Team Update 00

团队更新 00 版(Team Update 00)列举了 2020 版和 2021 版无限充能比赛手册之间的改动.

SUMMARY OF CHANGES 改动摘要

Figure 0-1: POWER CELL setup

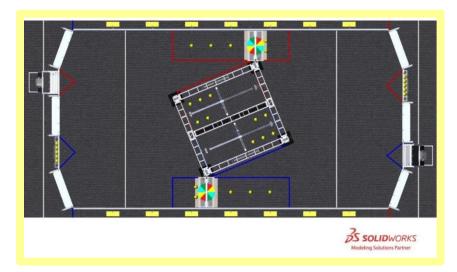
- A. five (5) POWER CELLS in each of the two (2) TRENCH RUNS
 - i. two (2) POWER CELLS are placed on each of the TRENCH baseplates further away from the center of the FIELD.
 - ii. three (3) POWER CELLS are placed centered in the width of each TRENCH RUN, spaced at 3-ft. (~91 cm) intervals. Small rings are used to keep them in place prior to the start of a MATCH. Rings are ½ in. (~3 mm) thick, 1¾ in. (~4 cm) diameter O-rings (McMaster Item#: 9452K63). Rings are secured to the carpet by tape.
- B. five (5) POWER CELLS placed on the BOUNDARIES floor protection inside each ALLIANCE'S RENDEZVOUS POINT as shown in Figure4-2.

5个能量电池放在各自联盟汇合点里的<mark>地面保护装置</mark>上的指定位置,见图 4-2 (Figure 4-2)

Figure 0-2: POWER CELL setup on BOUNDARIES inside RENDEZVOUS POINT

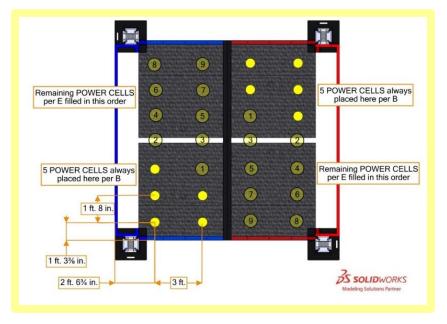
- RENDEZVOUS POINT 汇合点边界的改动: 各联盟汇合点外围的黑色边界已经移除,并以胶带线标记,这会使得汇合点看上去比原来的尺寸稍微大一点。细节见 3.2 区域与标记(3.2 Zones and Markings).
- RENDEVOUS POINT POWER CELLS 汇合点上能量电池摆放位置的改动: 原本放在黑色边界上的能量电池更改 位置放到了汇合点中,如图 4-1 和 4-2 (Figure 0-1 and Figure 0-2).

- C. five (5) POWER CELLS on the racks in each ALLIANCE STATION'S LOADING BAY,
- D. each of the three (3) teams may preload up to three (3) POWER CELLS in their ROBOT, such that they are fully and solely supported by that ROBOT, and
- E. remaining POWER CELLS (zero (0) to nine (9) per ALLIANCE, depending on decisions made in D) in the holes in the BOUNDARIES in inside the corresponding ALLIANCE'S RENDEZVOUS POINT as shown in Figure 4-2.

每个联盟剩下的能量电池(依据机器人上的能量电池数量,一般为0到9个)按照图4-2(Figure 4-2)的顺序摆放

在各自联盟汇合点<mark>里</mark>

Figure 9-4 BUMPER color example

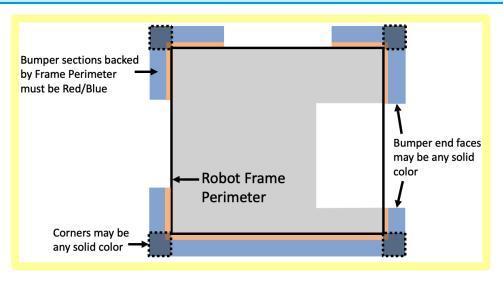
schedule distributed at the event (as described in <u>MATCH Schedules</u>). <mark>A BUMPER is considered primarily Red or</mark> Blue if all displayed BUMPER surfaces other than corners (i.e. everywhere the BUMPER is backed by the FRAME PERIMETER) displays the appropriate color. Any visible fabric other than the primary color must be a solid color. See

Figure 9-4.如果除四个角以外的所有可见的保险杠表面的颜色是红色或蓝色的话,这个保险杠被认为是**主颜色**

BUMPER corners and "ends", shown in Figure 9-4, must be solid in color, but do not need to be the same color as the rest of the BUMPER, as described in R21.如图 9-4 所示, BUMPER 角和"端"必须是实心的颜色, 但不需要与其余的 BUMPER 相同的颜色, 如 R21 所述...

Figure 0-4 TIMEOUT and BACKUP Coupon Timeline

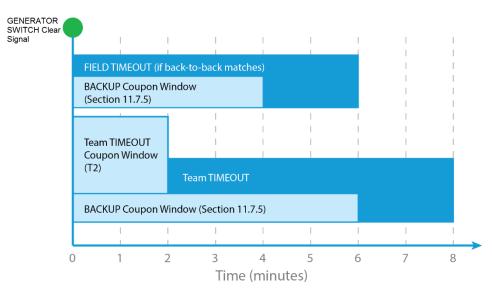
The GENERATOR SWITCH Clear Signal is indicated to teams with a change in the POWER PORT lights from green with white to fully green, as seen in Table 3-2 and Figure 3-19. FIELD STAFF will manually trigger the GENERATOR SWITCH Clear Signal after all ROBOTS have been removed from their GENERATOR SWITCH. 添加: 护盾开关的清除信号会用能源港的灯光从绿色带白色变成完全绿色的变化来指示给团队,如表 3-2 和图 3-19 所示。在所有机器人被搬离它们所属的护盾开关之后,场地工作人员将手动触发护盾开关清除信号。

T3. If an ALLIANCE wishes to use their TIMEOUT, the ALLIANCE CAPTAIN must submit their TIMEOUT coupon to the Head REFEREE within two (2) minutes of the GENERATOR SWITCH Clear signal preceding their MATCH. If there is no preceding MATCH, the TIMEOUT coupon must be submitted no later than two (2) minutes before the scheduled MATCH time. The TIMEOUT will begin two (2) minutes after the GENERATOR SWITCH Clear signal (i.e. at the end of the Team TIMEOUT Coupon Window depicted in Figure 0-4)
